ILLINOIS POWER COMPANY

December 1, 1981

Clinton Power Station Unit 1  
Docket No. 50-461

The attached material represents responses which were discussed with Messrs Ernie Rossi and Rick Kendall during a meeting on November 30, 1981. These responses were found to be acceptable as stated and resolve the issues. The following items are either closed or confirmatory depending on the action required:

Figure 1. Cold Reference Leg Design

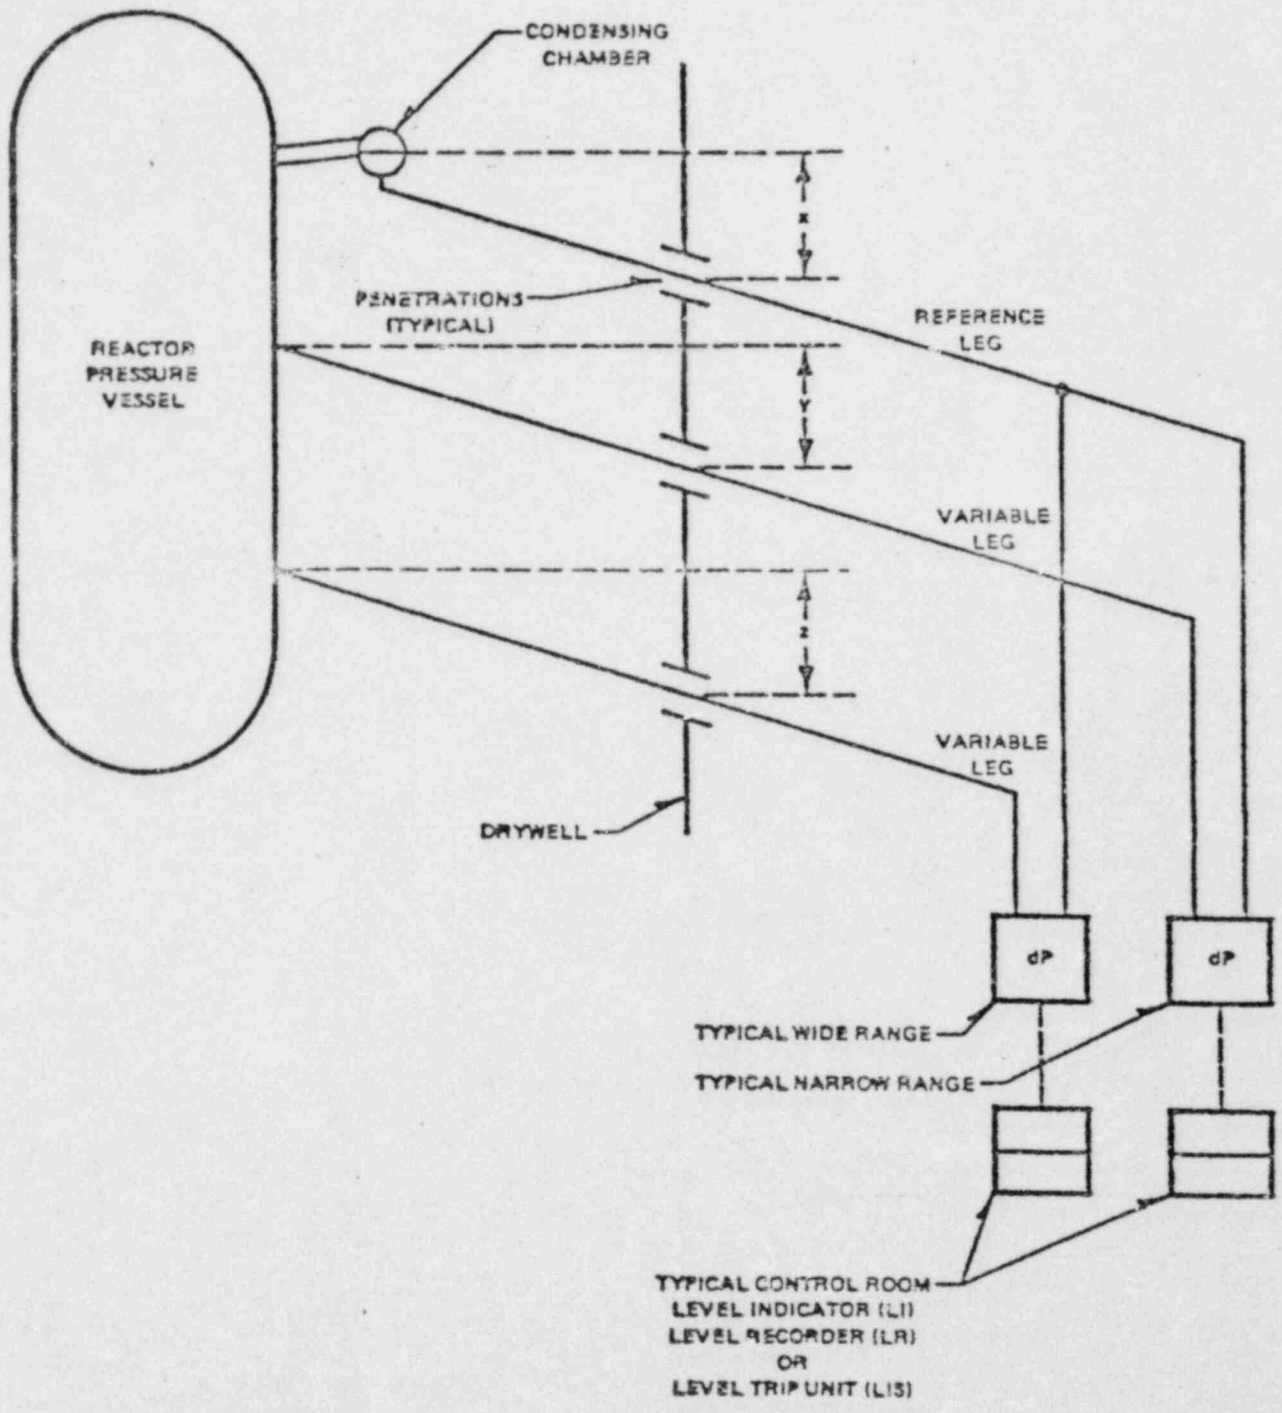
Applicant is asked to evaluate the effects of high temperatures in reference legs of water level measuring instruments subsequent to high energy line breaks. A preliminary evaluation has been completed and indicates that if, following a small break LOCA, drywell temperatures are allowed to remain above saturation too long, reference leg boil off could cause errors in vessel level instrumentation.

The cold reference leg reactor water level measurement design for Clinton Power Station (CPS) is illustrated in Figure 1. Reactor vessel water level is measured by differential pressure transmitters which measure the difference in static head between two columns of water. One column is a "cold" (ambient temperature) reference leg outside the reactor vessel, the other is the reactor water inside the reactor vessel. The measured differential pressure is a function of reactor water level.

The amount of error due to boil-off is a function of the amount of vertical drop of the reference leg inside the drywell. The following is an analysis of the reference leg boiling problem as applicable to the CPS design.

Small (e.g., .01 ft<sup>2</sup>) and intermediate (e.g., .04 ft<sup>2</sup>) break accidents (LOCA's) that discharge steam into the drywell (at temperatures as high as 330°F) for an extended time period could result in substantial heat-up of components/air in the drywell (including reactor water level sensing lines). If the reactor is subsequently depressurized below 103 psia, water in the reactor water level sensing lines located in the drywell will flash.

General Electric has conservatively evaluated many steam break accidents and has determined that, for the worst case scenario (small break accident with ADS operation after 1800 seconds), flashing will result in a loss of up to 20% of the water in the sensing lines. Water in the variable leg sensing line will be replenished by drain back from the reactor, while water in the reference leg sensing line will continue to be gradually depleted due to boil-off. Loss of water from the reference leg results in a sensed reactor water level that is higher than the actual reactor water level.

Based on our evaluation of the automatic operation of systems and manual actions to be taken under emergency procedures during the event postulated, we find that it is highly unlikely that any action will be taken based on erroneous level information and that adequate emergency procedures are provided *which* specifically identifying this unique situation and which spell out the measures to be taken to rectify erroneous level readings. It is our conclusion that the design of the reactor vessel level measuring system is acceptable and sufficient provision has been made for potential errors due to boil-off of the reference leg under small steam break conditions.

The CPS FSAR will be revised to include a description of the temperature monitoring associated with the reference leg.

Figure 2. Typical Reactor Level Indicators on Reactor Control Panels

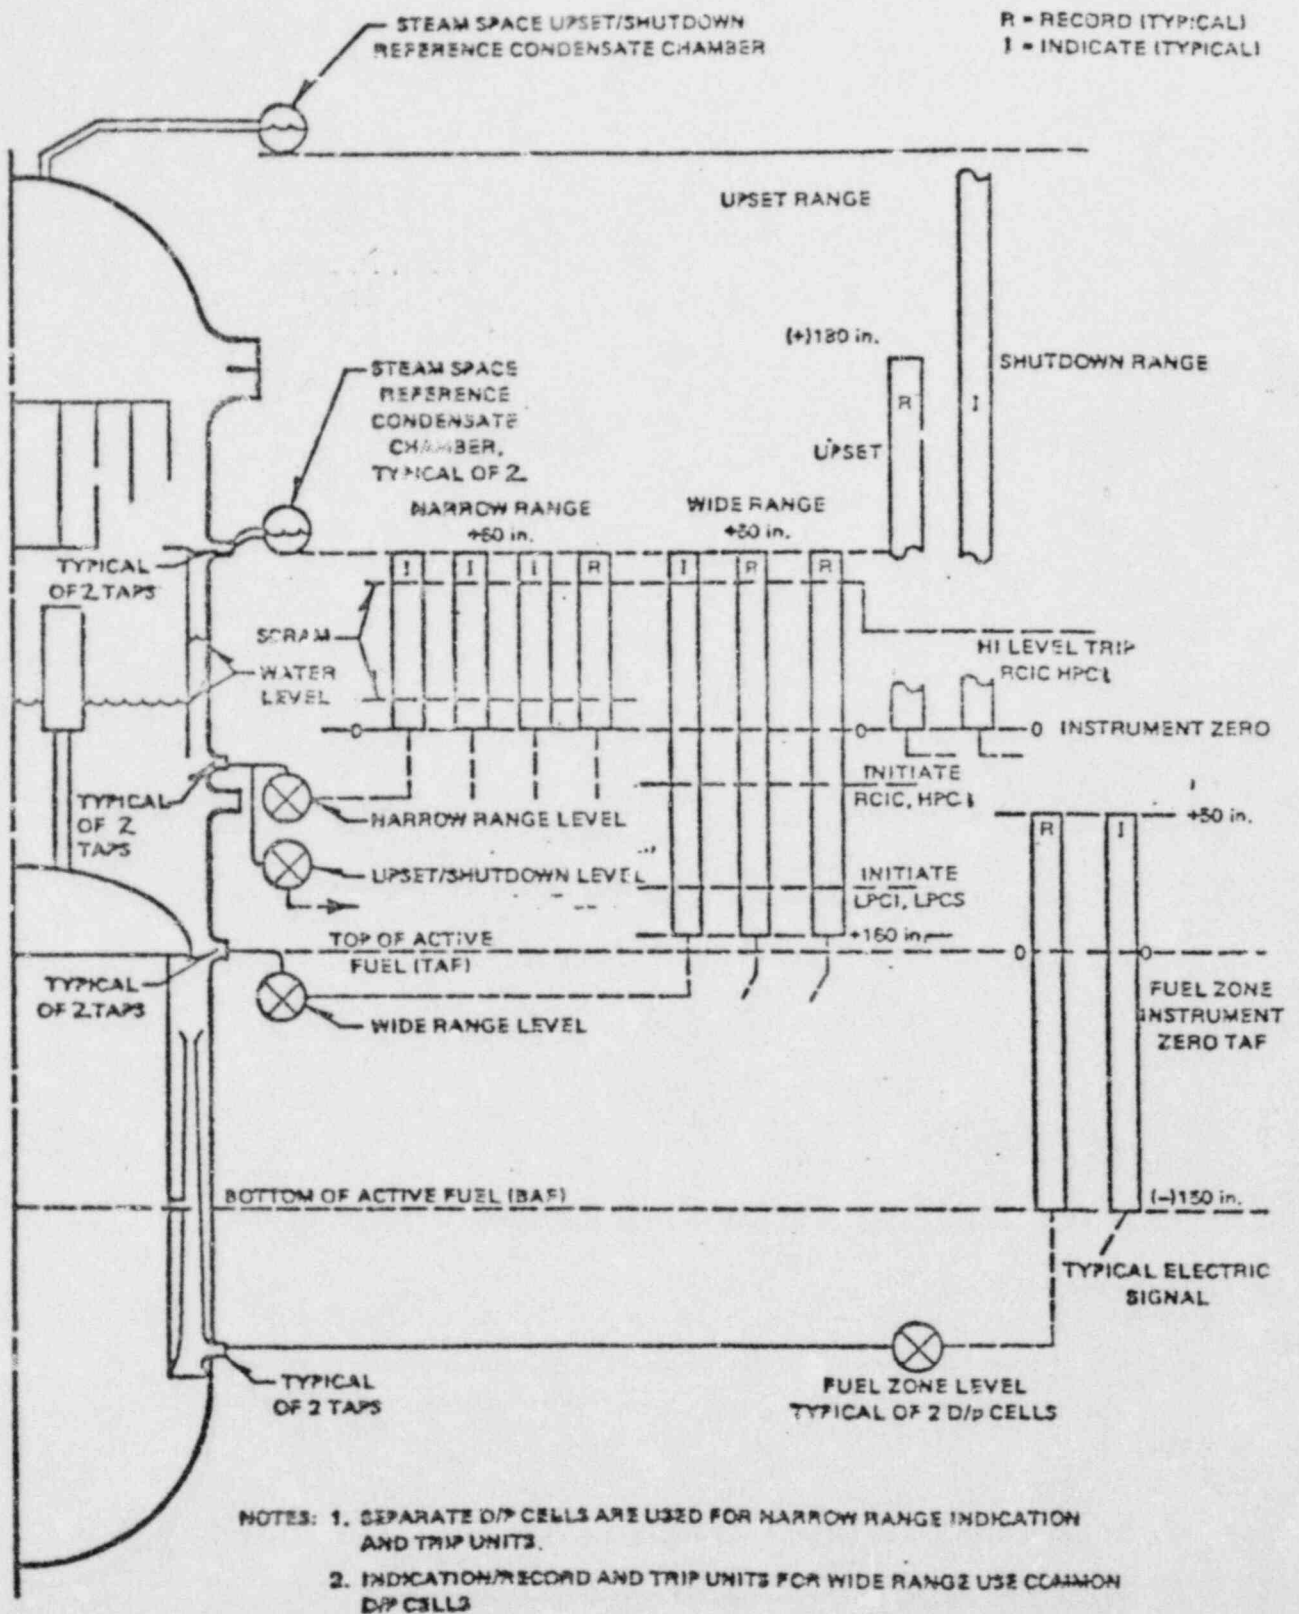
above the tap and is the "variable leg" in the differential pressure measured by the transmitter. Lower taps for various instruments are located at various levels in the vessel water zone to accommodate both narrow- and wide-range level measurements (see Figure 2).
